Addendum #01

Date: November 28, 2022

Project: Longview School District HVAC Chiller Replacements and Indoor Air Quality Improvements

A100

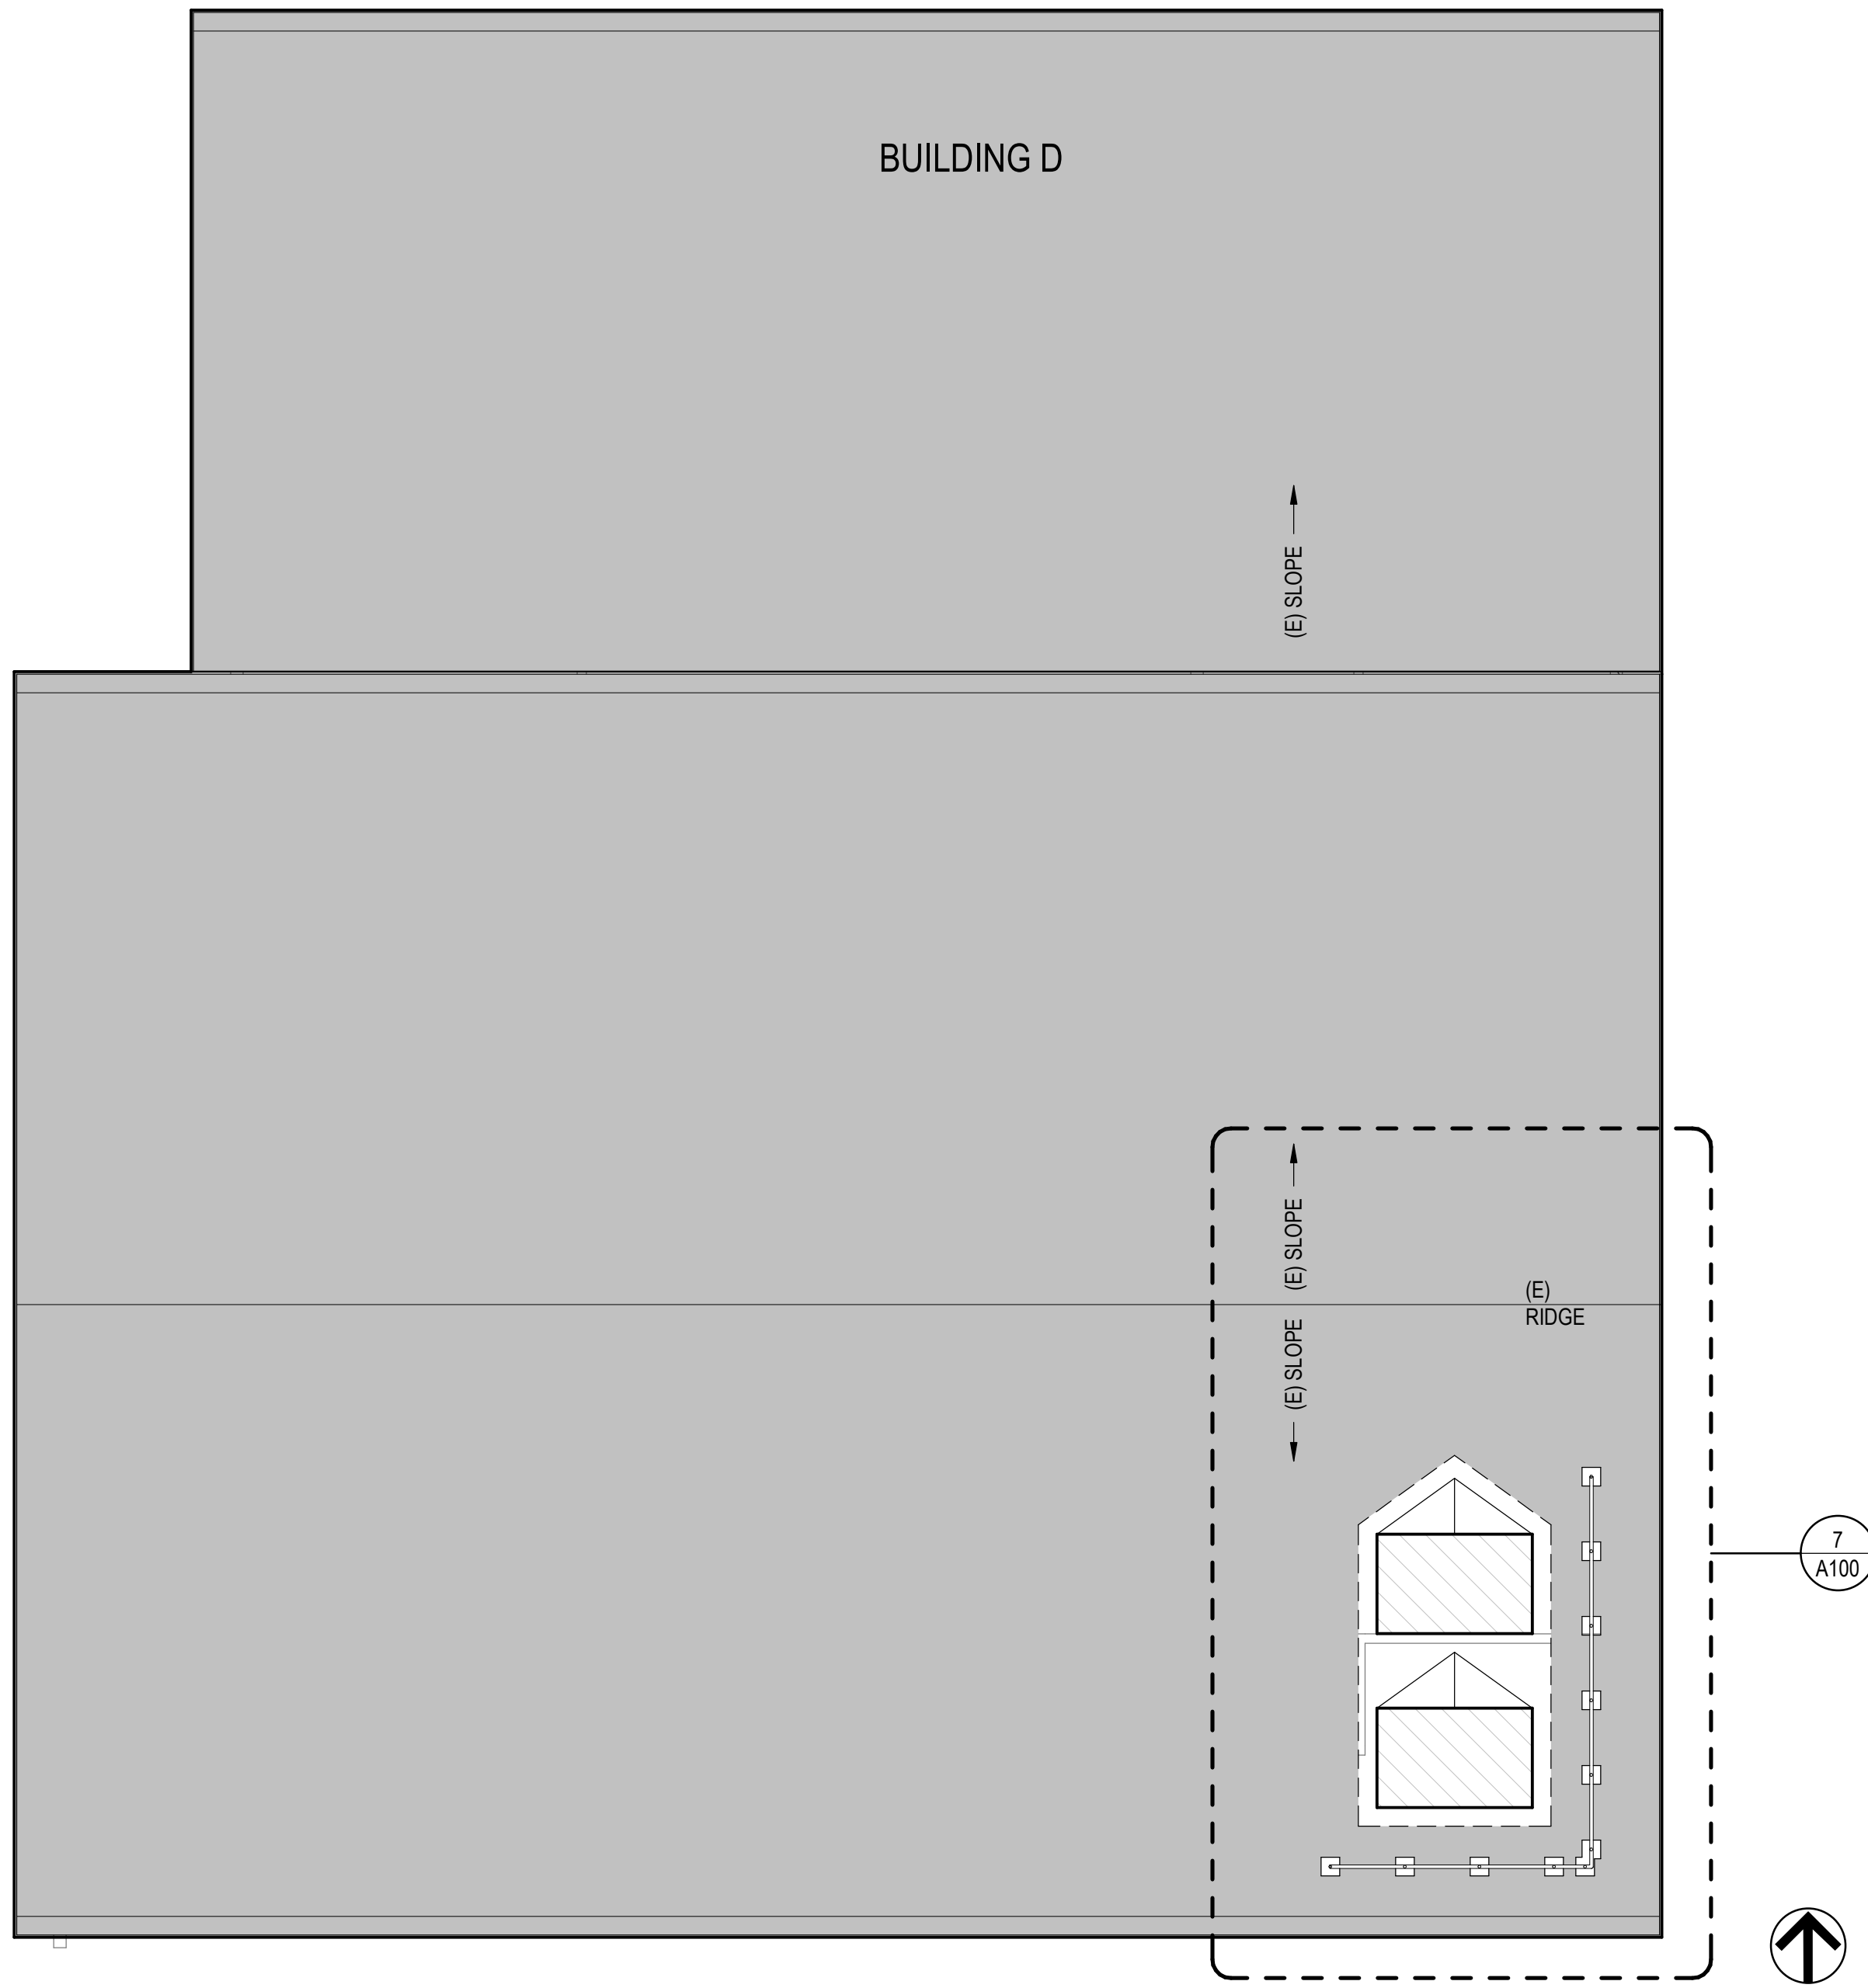
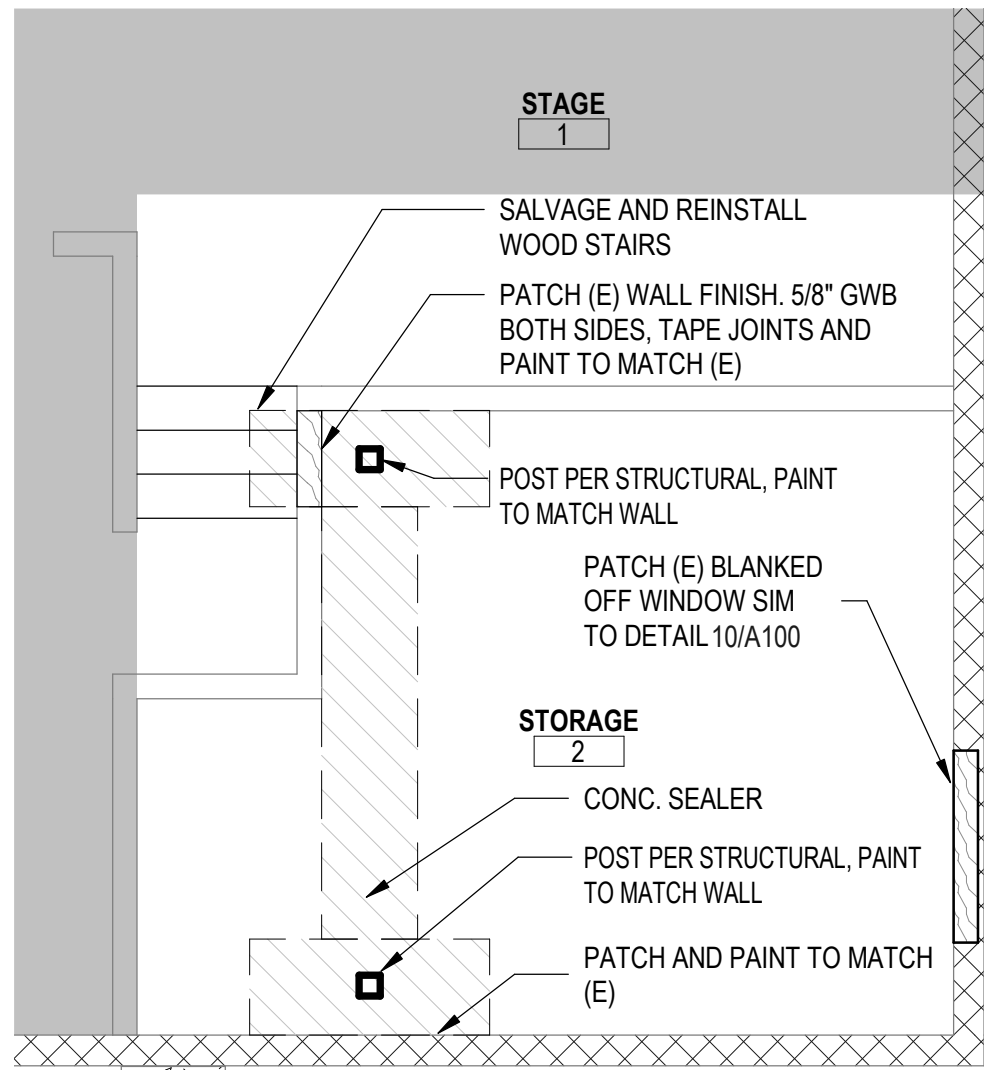
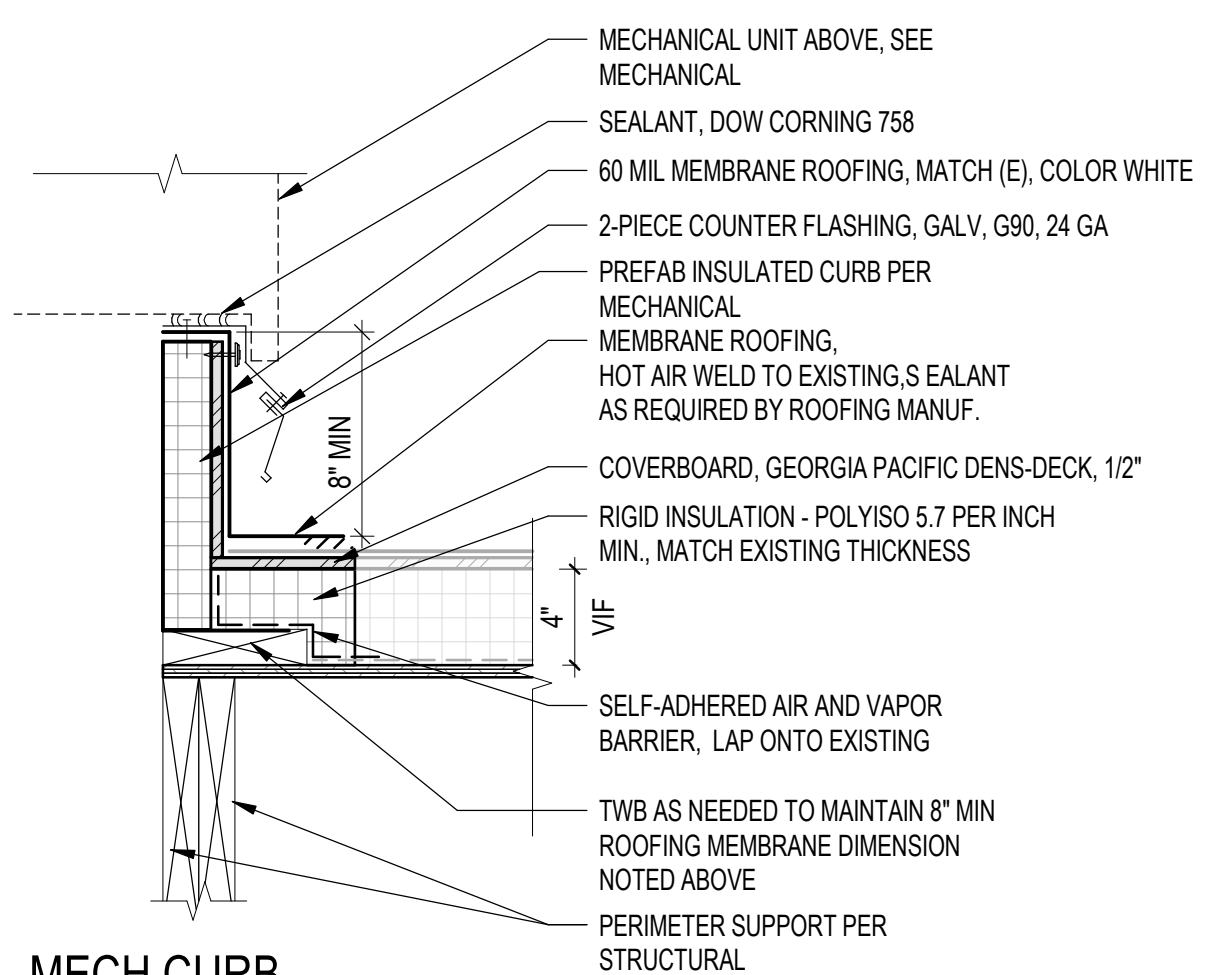
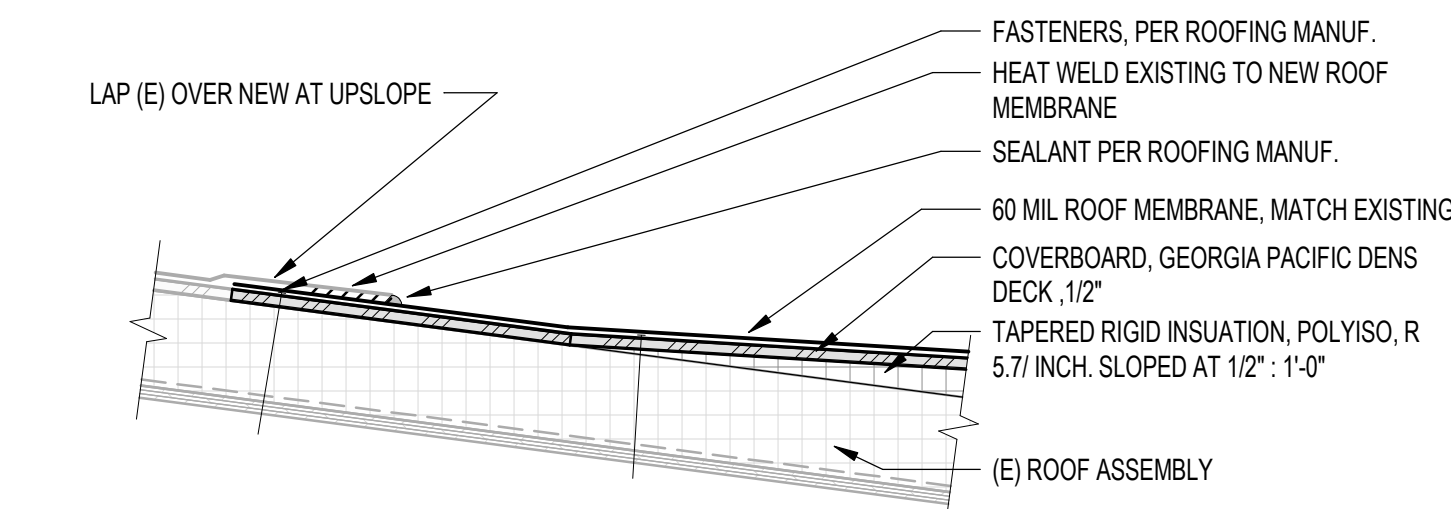
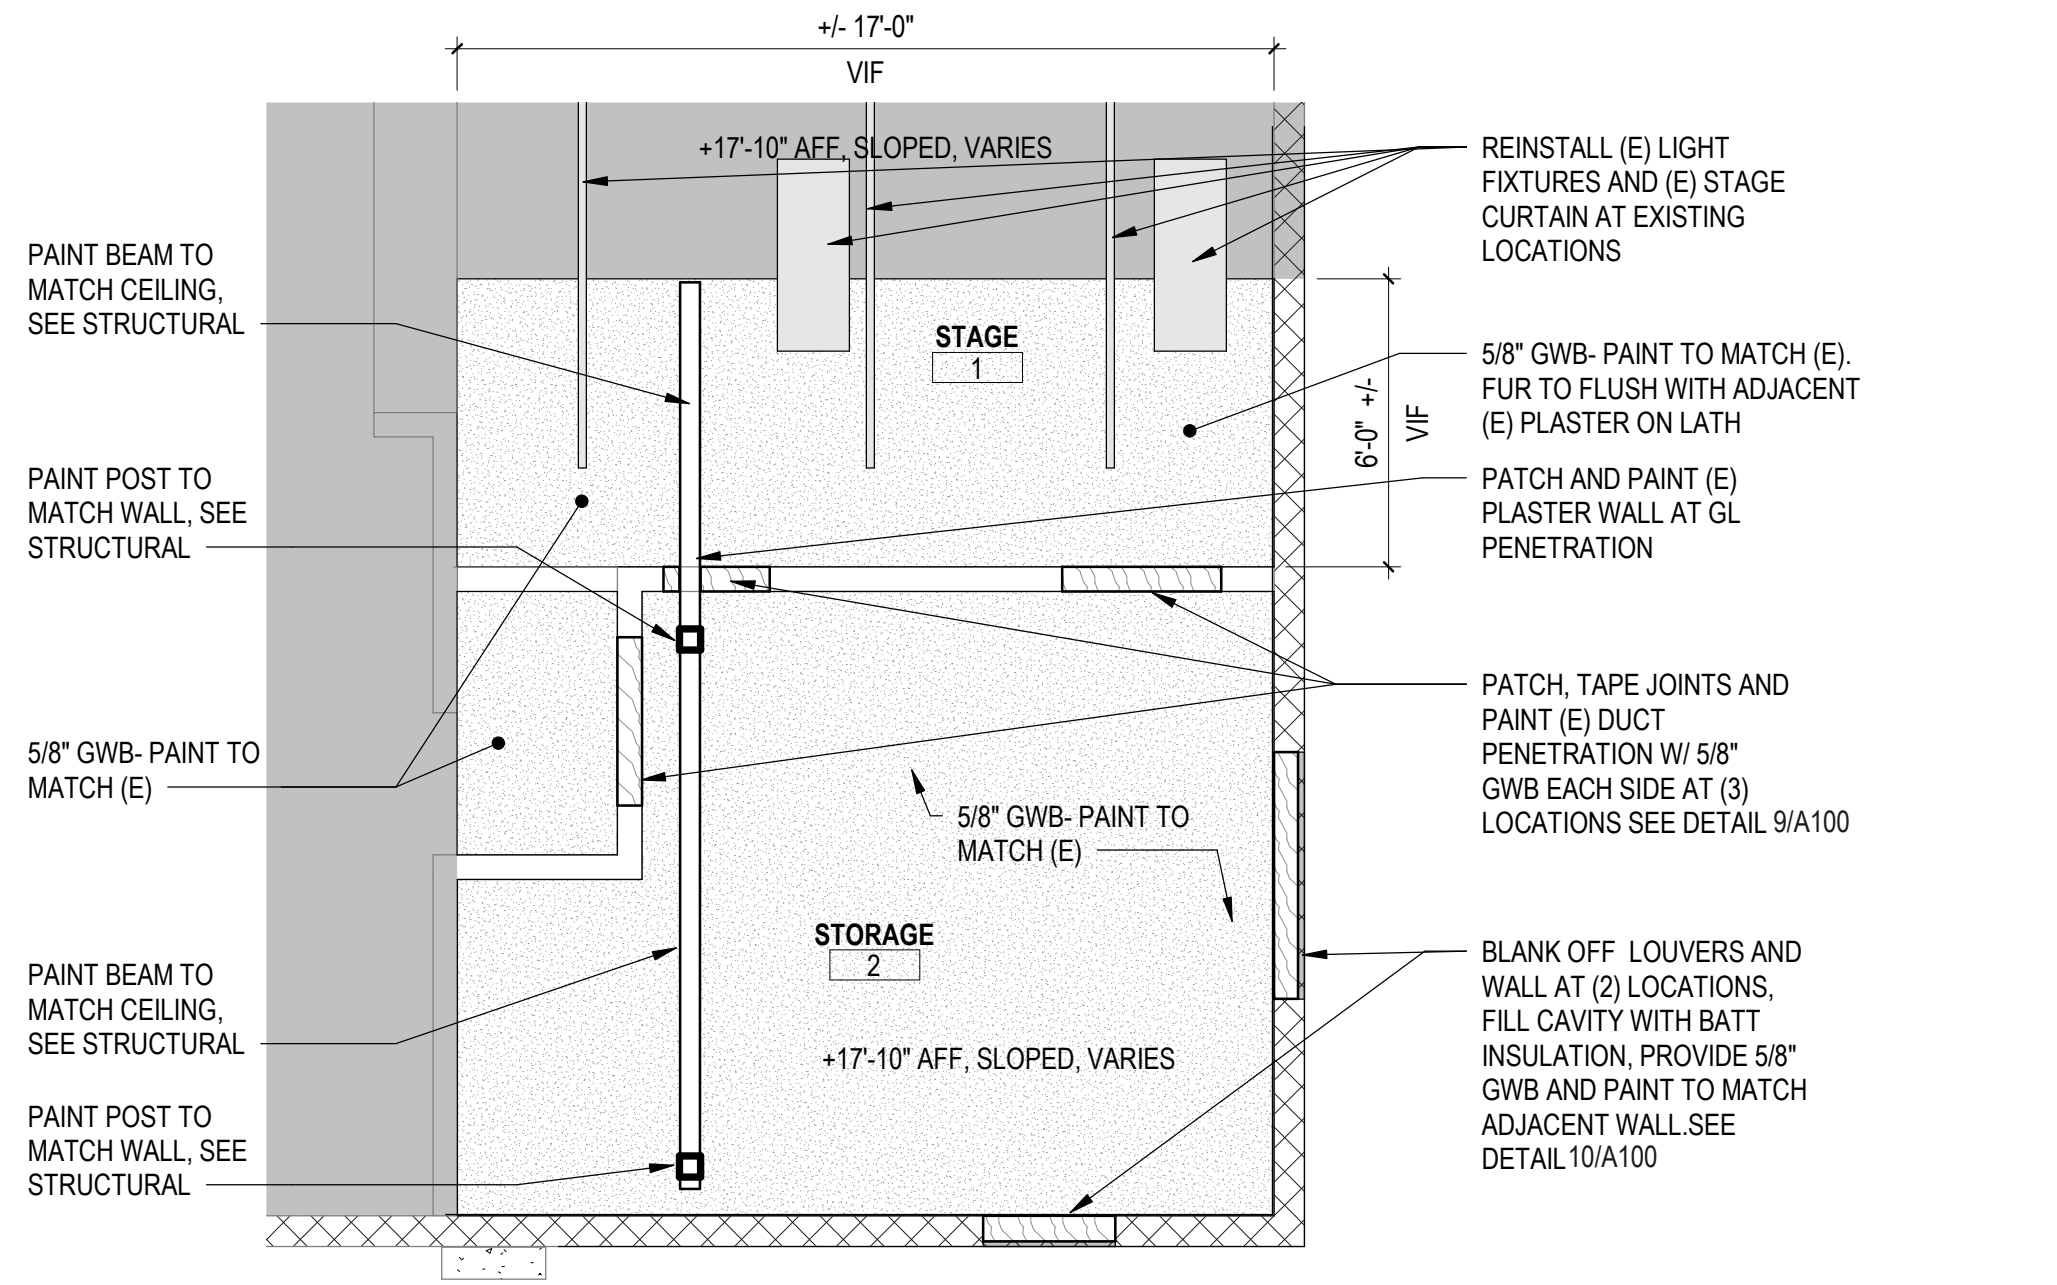
Add. #01 **ADD:** SHEET A100 – COLUMBIA HEIGHTS PLAN in its entirety per attached Sheet A100 to clarify painting of interior elements, roof patching scope, and patching of interior walls, floor, and ceiling.
